RESPONSE TO NRC CONCERN WITH TEMPERATURE EFFECTS ON SAFETY-RELATED ELECTRONICS IN MAIN CONTROL ROOM

In a recent NRC Inspection Exit Meeting and USNRC Inspection Report 05000458/2015010, Attachment 3, a concern was expressed by the NRC that the evaluation of the Loss of HVAC in the Main Control Room does not appear to be conservative with respect to the potential impact on safety-related electronic components. Two documents were cited as a basis for this concern:

Figure 3: Relative Humidity in the Horseshoe Area for Case 1

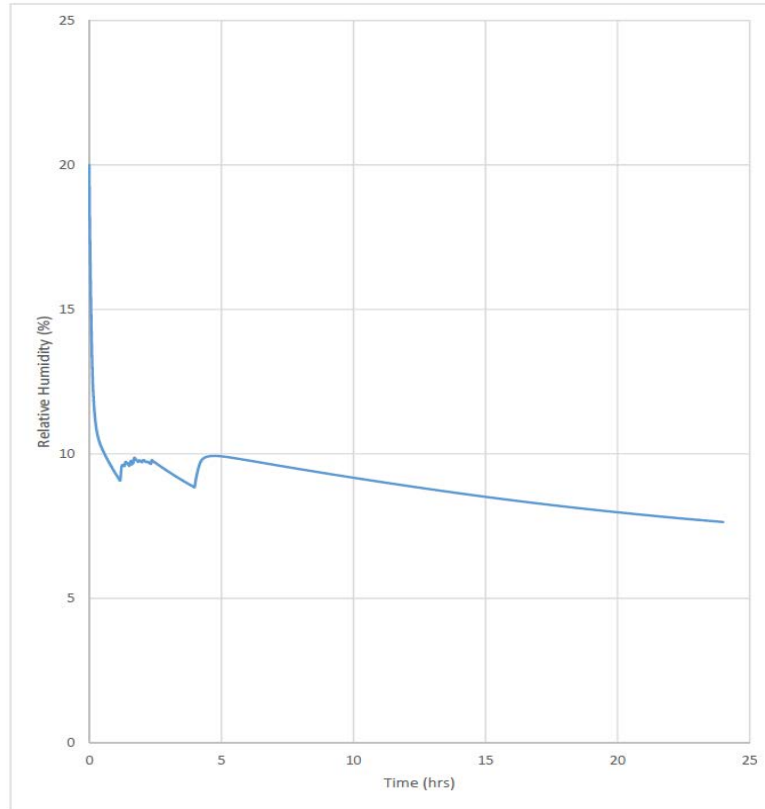
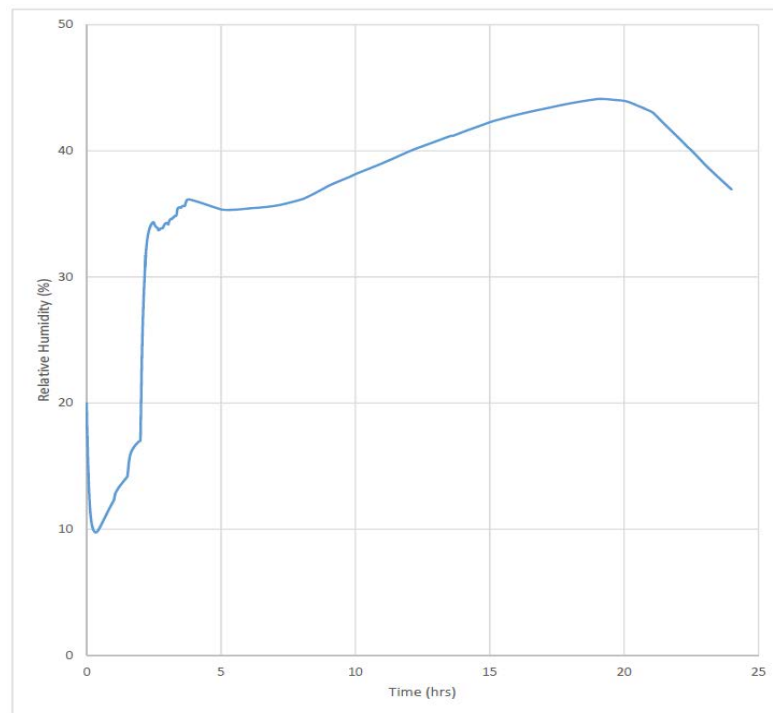
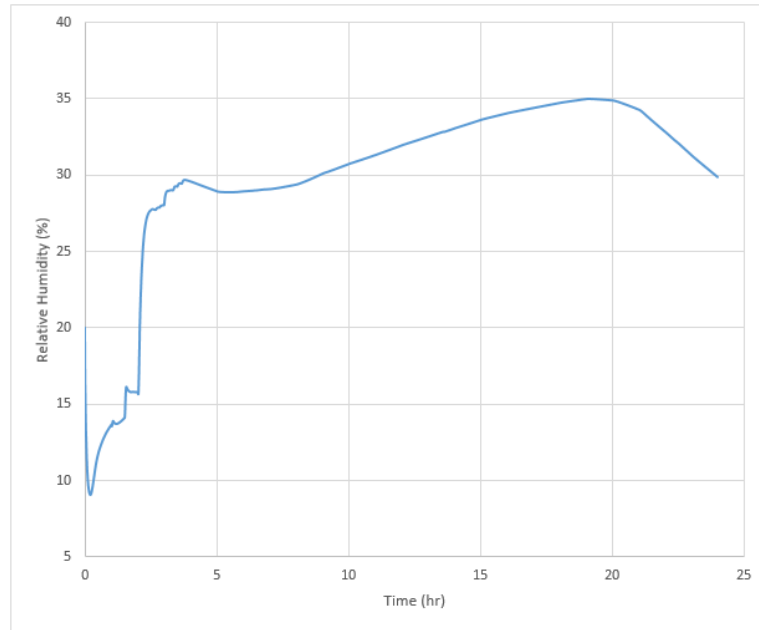
Accounting for all inputs, the NRC considered that the licensee’s posture of ensuring the control room was maintained less than 120°F would only be acceptable for scenarios which would only result in elevated temperatures up to four hours and only if they also demonstrated that humidity did not rise appreciably in those four hours.”

The control room equipment is designed for a maximum temperature of 122°F. The GOTHIC model (Reference 5) shows that ambient air temperatures will not exceed the equipment design maximum temperature of 122°F. Additionally, Figures 3, 6, 7, and 9 show that humidity will remain low and within the Main Control Room's Environmental Design Criteria. Therefore, the 4-hour limit is not applicable to River Bend Station Main Control Room.

Figure 8: Temperature in Subvolume 171 for Case 2

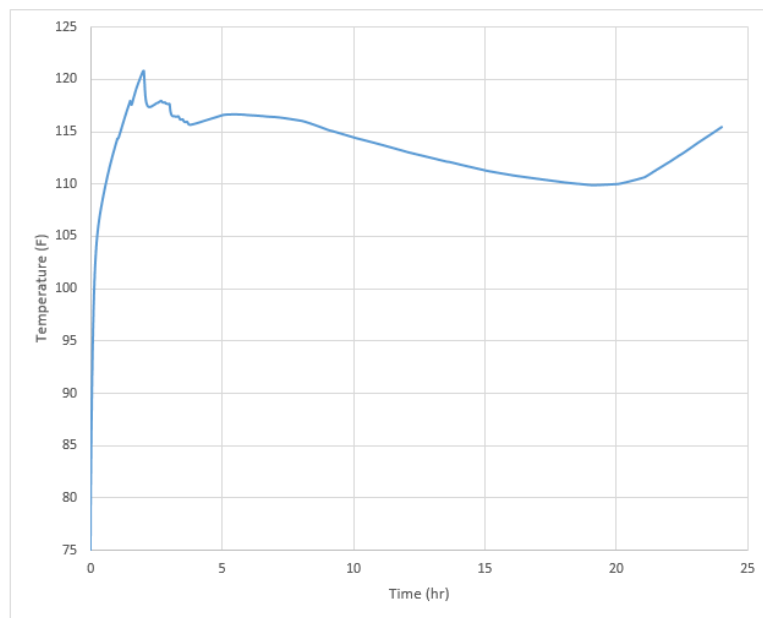
The inspectors found an incorrect value for the specific heat capacity of steel in Calculation ENTR-078-CALC-003 in September 2015. The licensee used a value of 0.16 BTU/lbm-°F, where a more appropriate value of 0.116 BTU/lbm-°F should have been used. The correct value resulted in a 14°F increase in control room temperature. The licensee then performed another analysis using the correct heat capacity of steel and added more steel (heat sink) at the same time. The licensee reported that they added the steel to the analysis to account for steel identified in the control room during a walkdown performed in July 2015. The effect of using the appropriate heat capacity of steel with these added steel heat sinks produced a final control room temperature of 119.9°F. This value of 119.9°F included use of the service water contingency to the coils of the air handling units within 2 hours. If the service water contingency is not credited, the main control room temperature rises above 120°F. This analysis did not include the several non-conservatisms described above. The inspectors determined that the control room would exceed 120°F during a loss of control building cooling event, given the non-conservatisms in the licensee’s analysis, and the high failure probability of the service water contingency.”

2. "When requested, the licensee could not provide the NRC a detailed analysis of the equipment survivability of control room equipment at the temperatures which would be expected to be experienced during a postulated heat-up scenario. The licensee instead provided analyses to indicate the control room would never reach 120°F, a temperature at which they assumed equipment would not be affected."

The subvolume with the highest temperature (120.8°F) that contains safety related equipment is subvolume 171 surrounding panel H13-P694, Reactor Protection System Logic Div D (Figure 8). The peak temperature occurs 2.02 hours following the start of the event; for less than 11 minutes of the entire 24-hour event, subvolume 171 has a temperature above 120°F. For the remainder of the event, subvolume 171 experiences temperatures below 120°F.

2. Design temperature of the Main Control Room equipment will not be exceeded, therefore a detailed analysis of the equipment survivability is not required. GE-22A3888, Rev. 3 (Reference 7) provides a design temperature of 122°F for the Main Control Room equipment. AOP-0600, Rev. 9 (Reference 6), in step 5.1.4 instructs Operators to open the control panel doors. Per NUMARC 87-00 (Reference 4), opening panel doors allows adequate air mixing and internal panel temperatures will be in equilibrium with Main Control Room ambient air temperature. The GOTHIC Model (Reference 5) shows Main Control Room temperature will not exceed 122°F (temperature will peak at 120.8°F around Safety Related control panel H13-P694 and remains above 120°F for only 11 minutes).
